BIDDING ADDENDUM

ADDENDUM#: 01
Date: 8.27.26
Project: Bank of Utah Spanish Fork
Project #: 26002

Clarifications and bidder question responses.

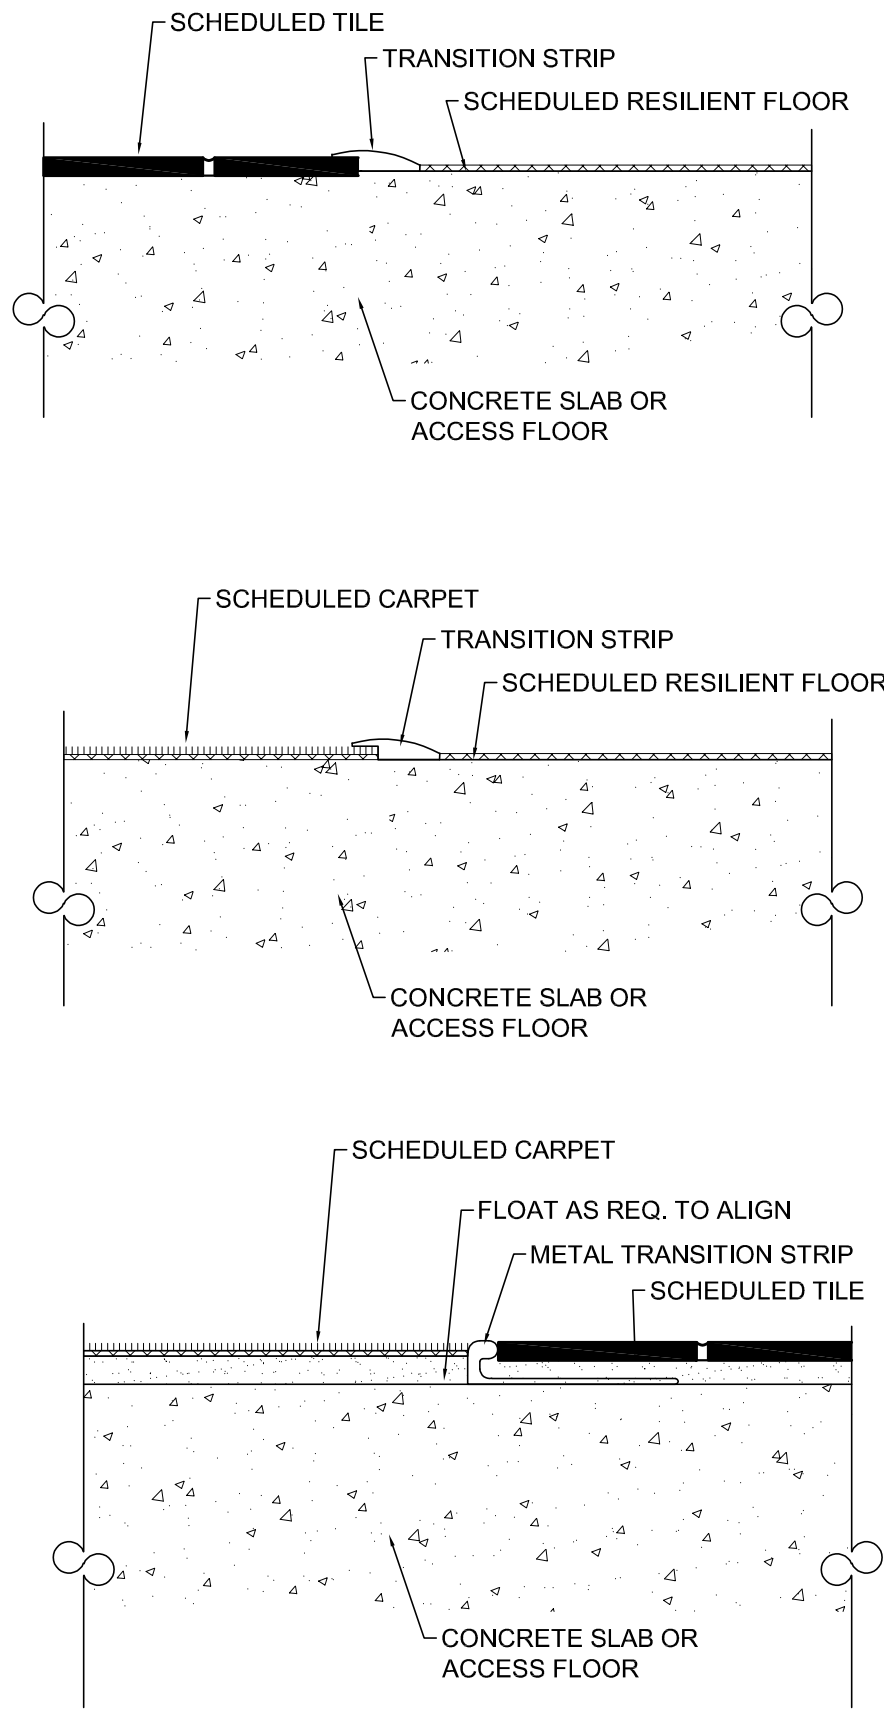
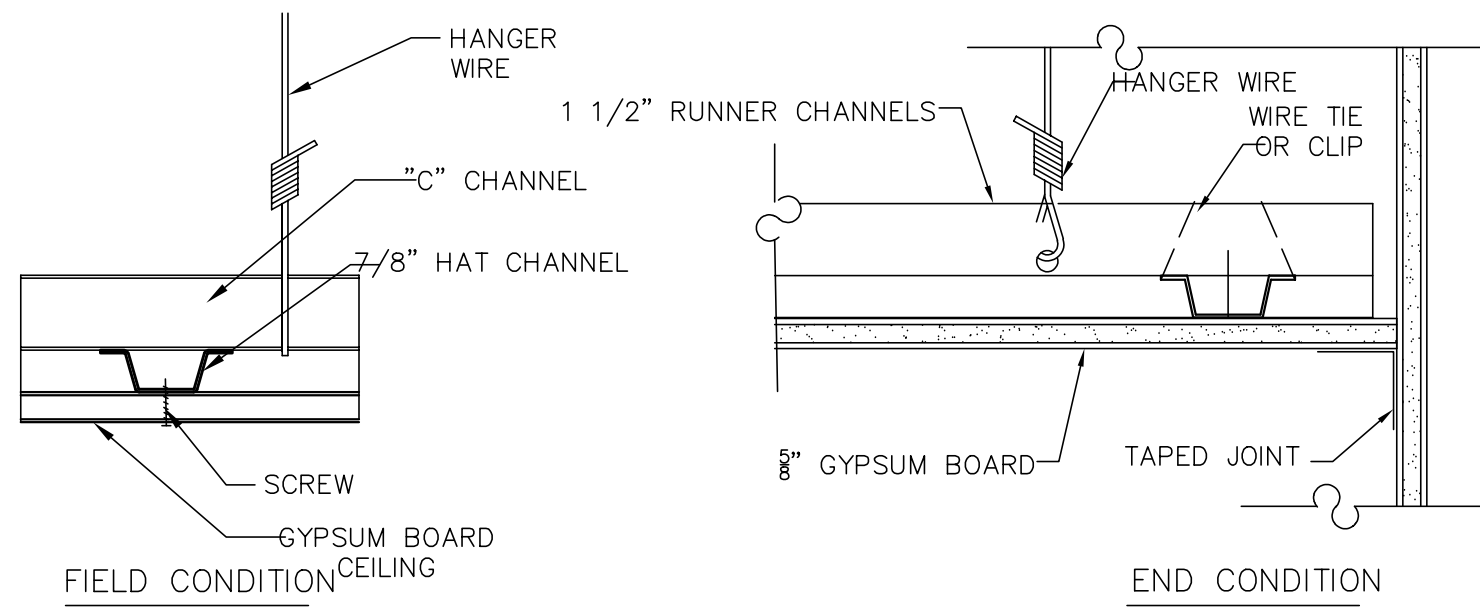
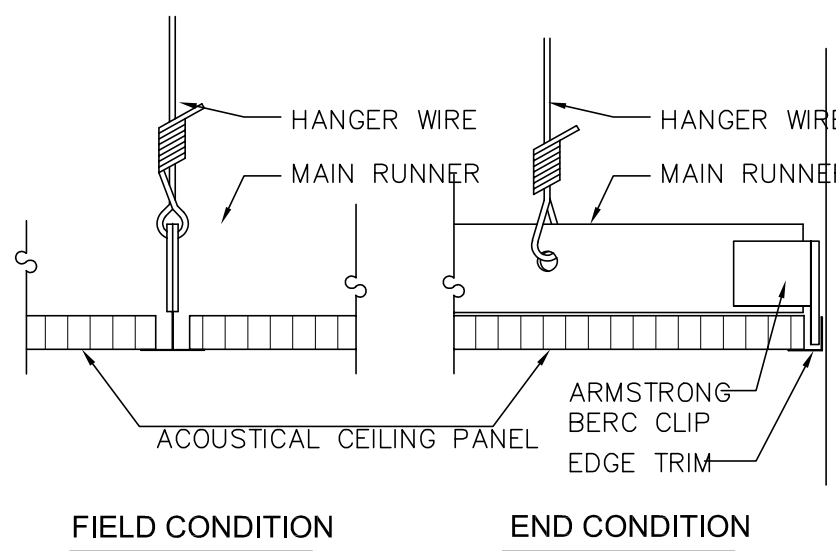
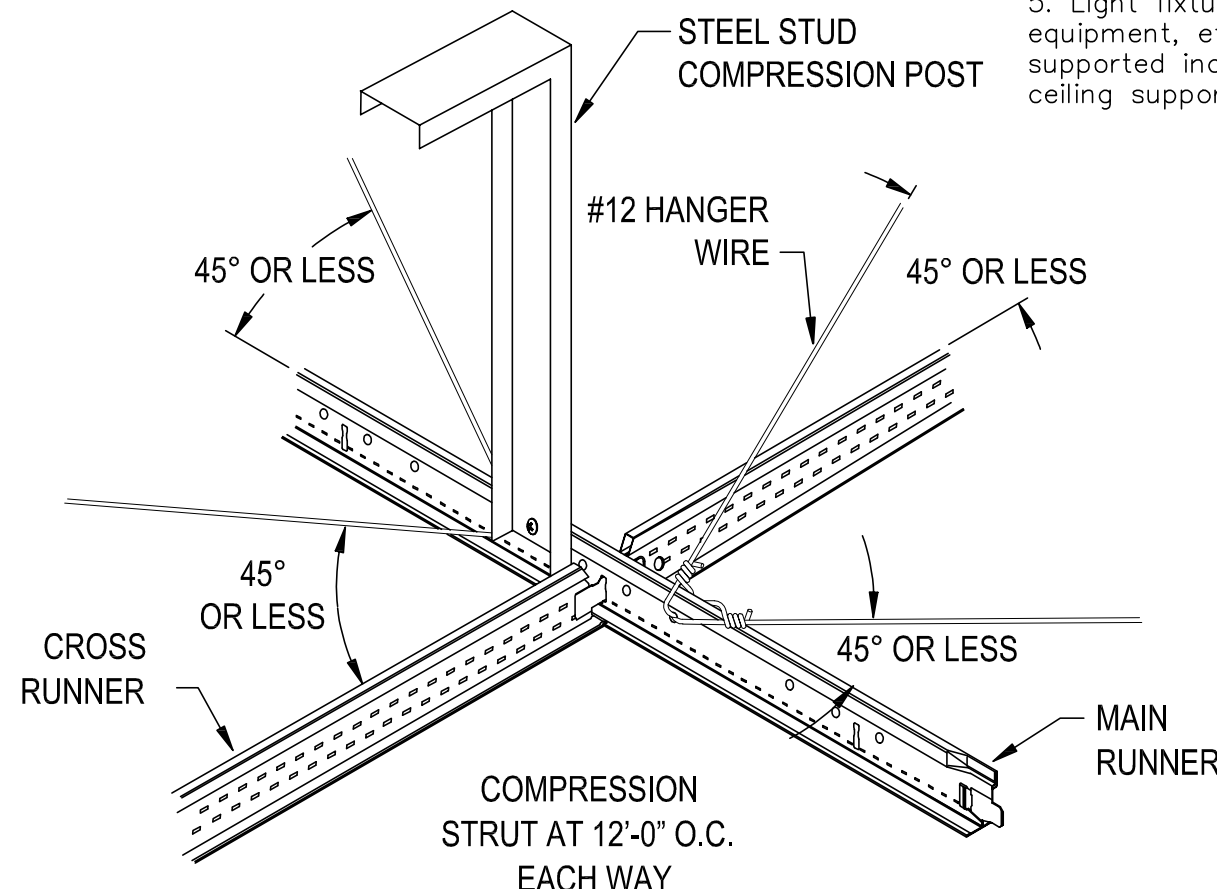
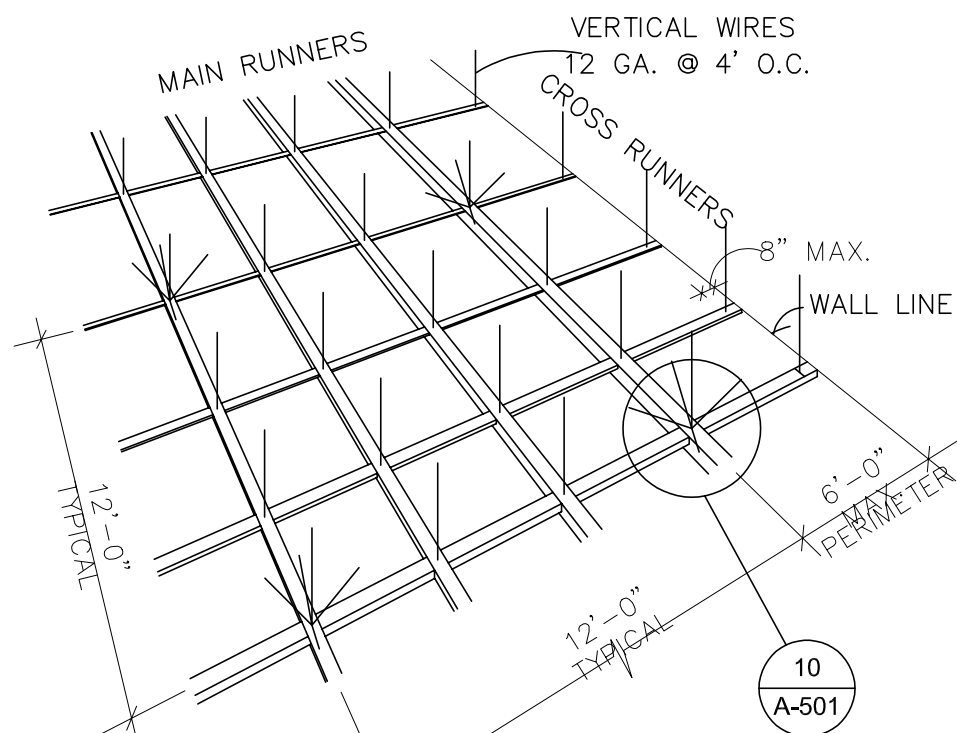
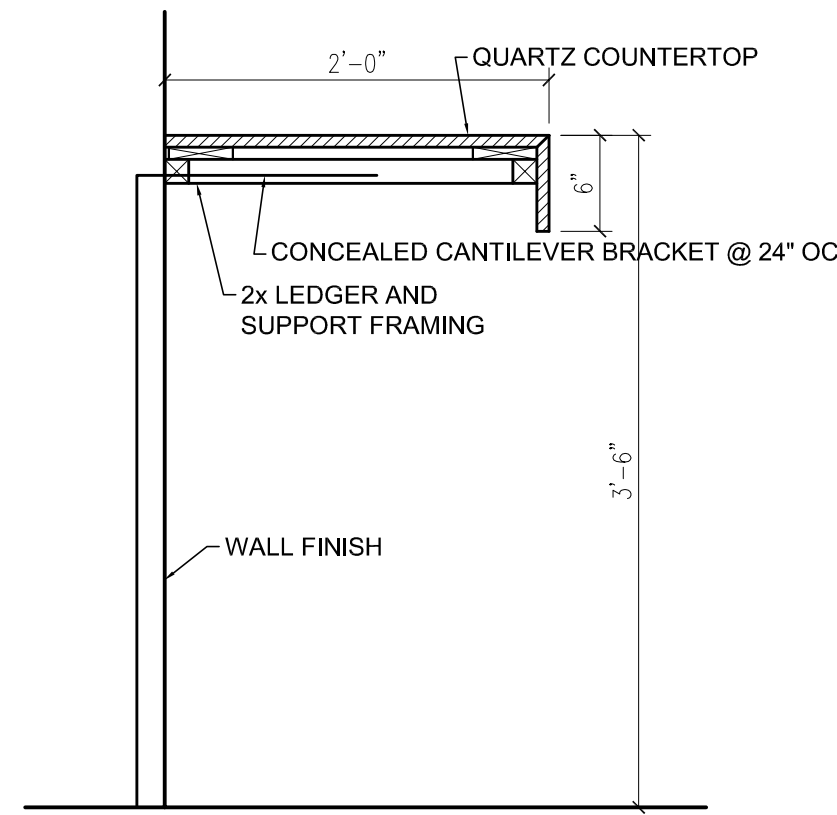
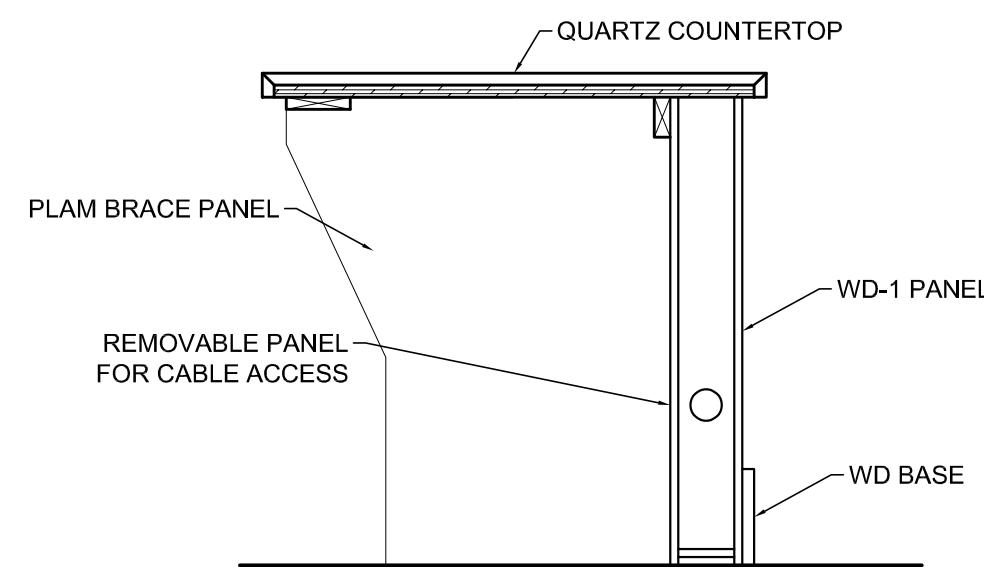
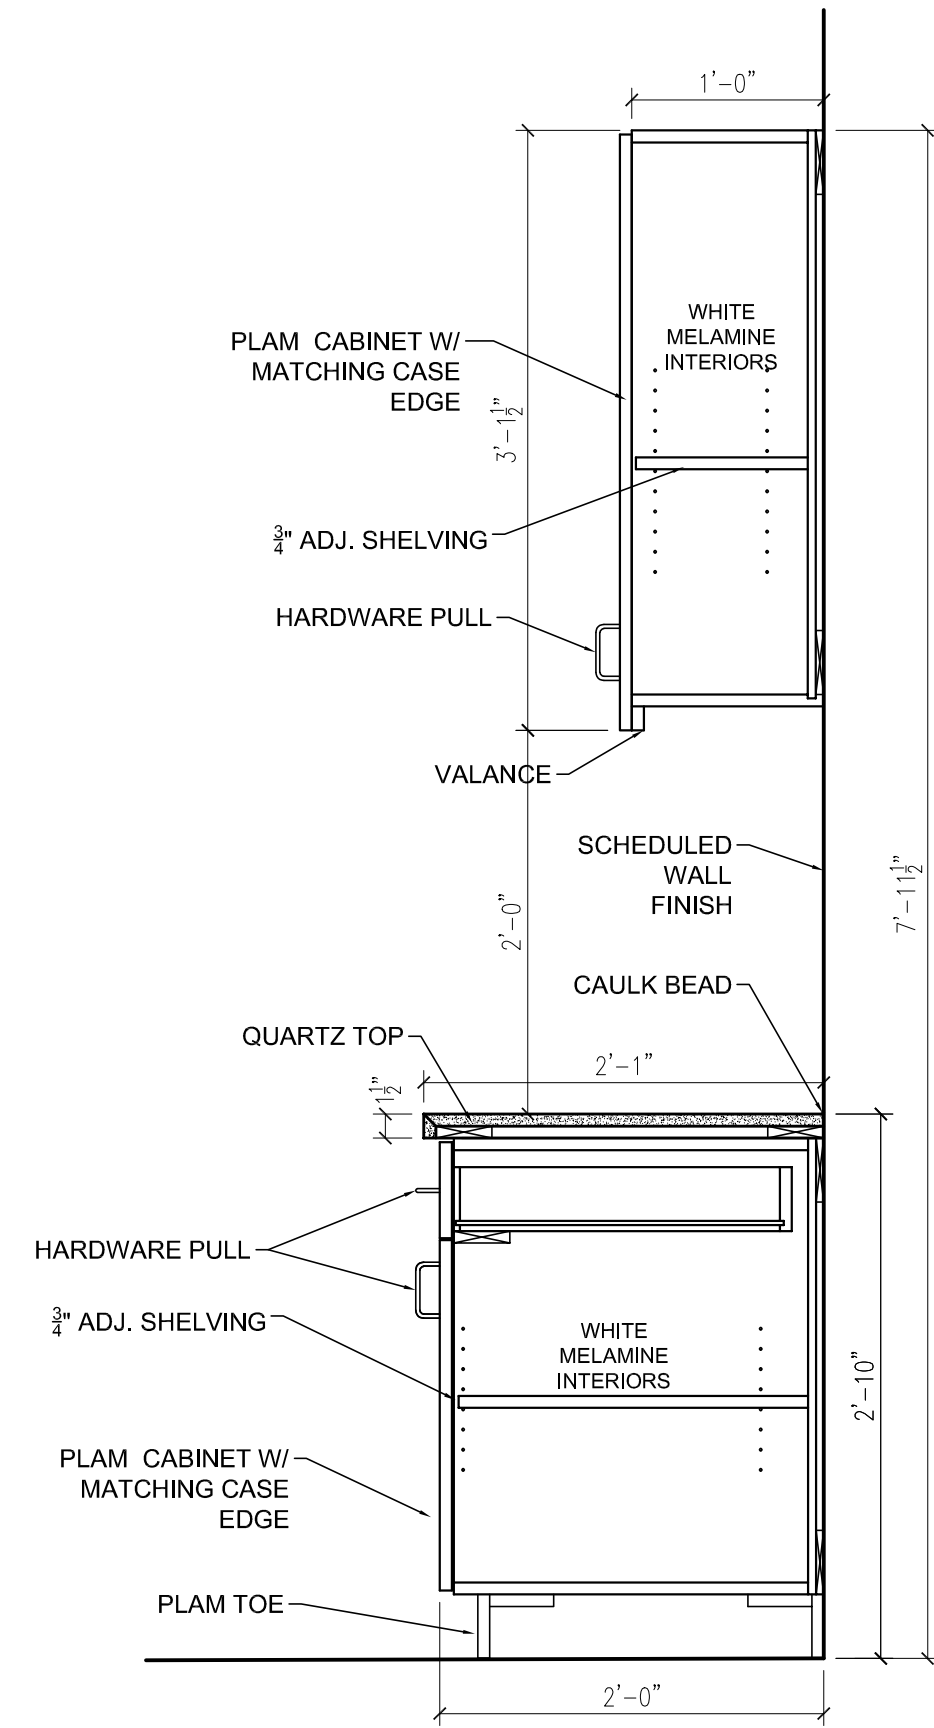
A501

- cleaned up overlapping details
